**SECTION 00 90 01
BIDDING AND CONTRACT REQUIREMENTS
ADDENDUM NUMBER (06)**

Re: ADDENDUM NUMBER (06) TO THE BIDDING DOCUMENTS FOR

Bid 24-032 Elgin Sports Complex Expansion

Architect's Project Number: 14106

DRAWING TITLE
 STORM SEWER
 PLAN AND PROFILE
 SCALE: 1" = 20'
 PROJECT NUMBER: 14106
CU-210
 DRAWING NUMBER

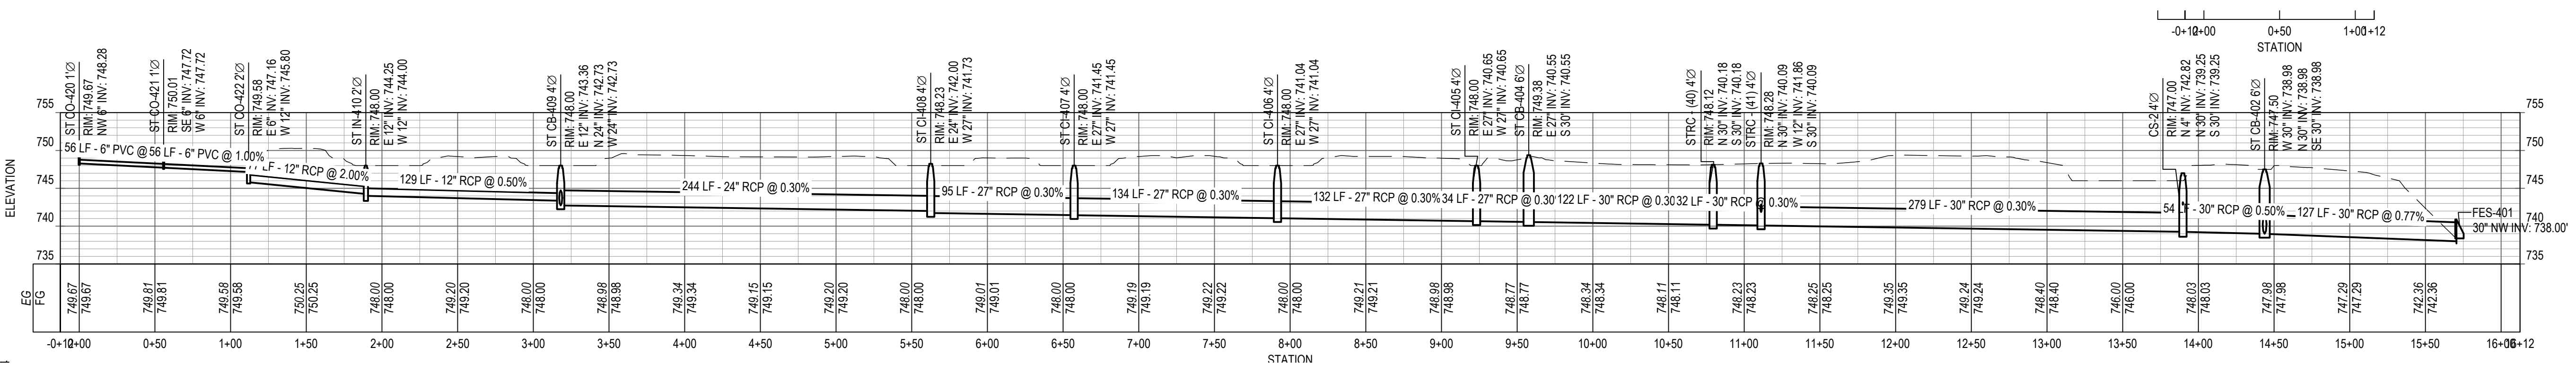
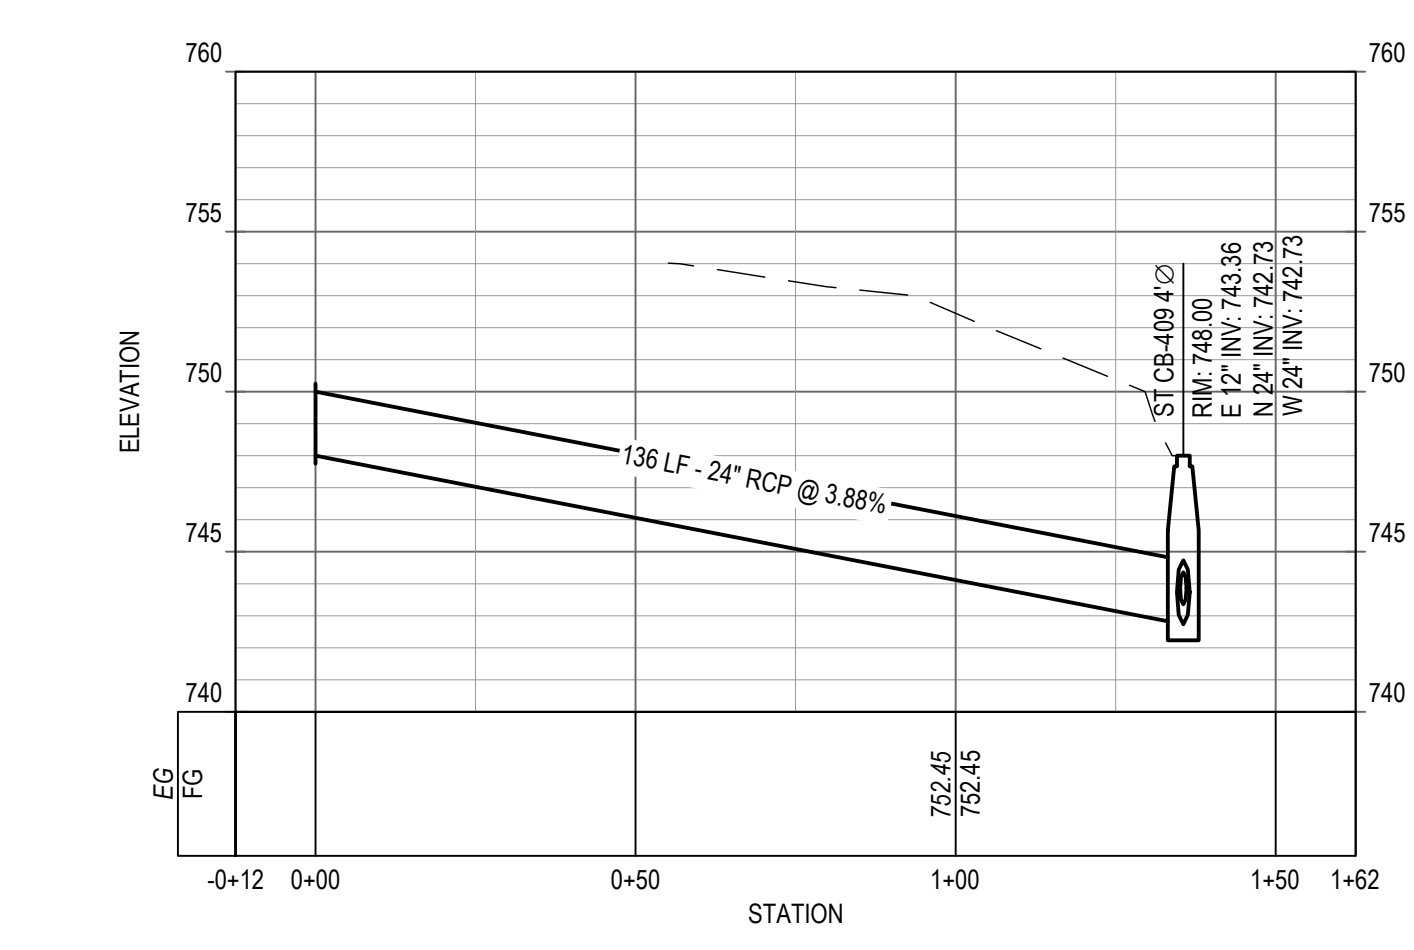
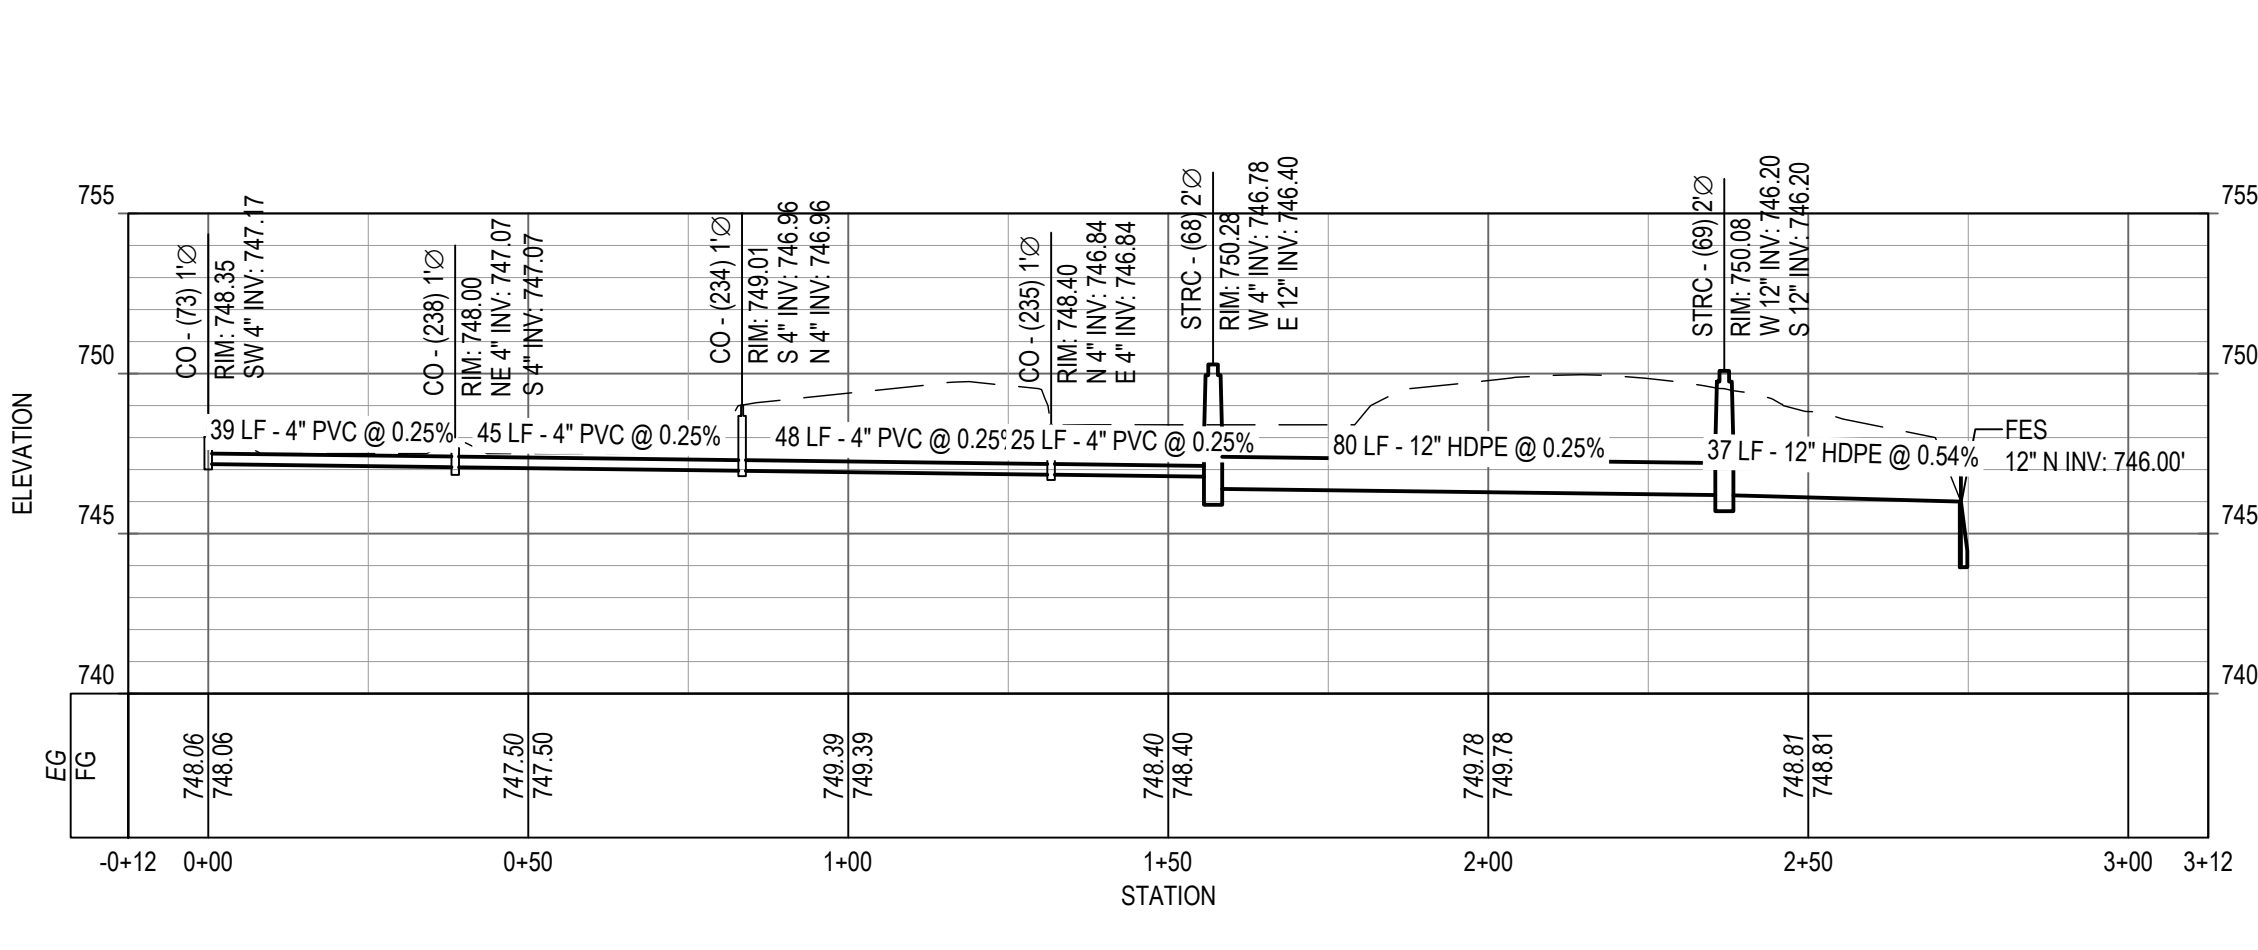
14. ALT-104 - ALTERNATE 4 -PARKING LOT 2: Updated grading, site layout, planting, and added wall and guardrail.
15. ALT-500: Modified Detail 8 Xtower height.
16. S-500: STRUCTURAL DETAILS – Updated Cistern Foundation Detail
17. CU-100 through CU-103 – UTILITY PLAN: updates to water main design layout
18. CU-208 through CU-214 – STORM SEWER PLAN AND PROFILE: updated pipe materials, structure, and storm sewer pipe depth/slope.
19. CU-215 Water Main: added profiles to provide design information for portions not previously released, updated sheet notes and legend, updated pipe materials, size, fittings/appurtenance, and depth/slope.

17. On Page CU-214 you show multiple 24" concrete pipes going into 24" catch basins. This is not possible. There are other pages that show 12" pipe going into 12" catch basins or more 24" pipes into/ from a 24" basin as well. Please review and update the basin or pipe sizes to ones that are possible. **See updated CU Series sheets in Addendum 6.**
